PRIME CAP (BD) LTD

21 October 2025

Structural Inspection Report

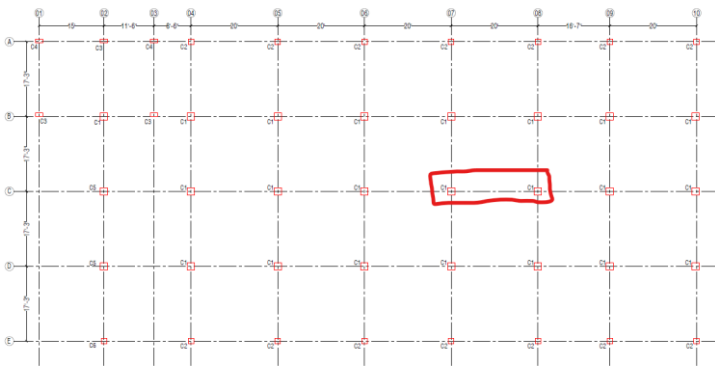
Building-1 (Main Building),	Seven storied (G+6) RC Building.
Building-2 (Security & CFDS Building),	Single storied RC Building.
Building-3 (Utility Building)	Two storied (G+1) RC Building.
Building-4 (Shed Building).	Single storied steel shed with underground fire pump room
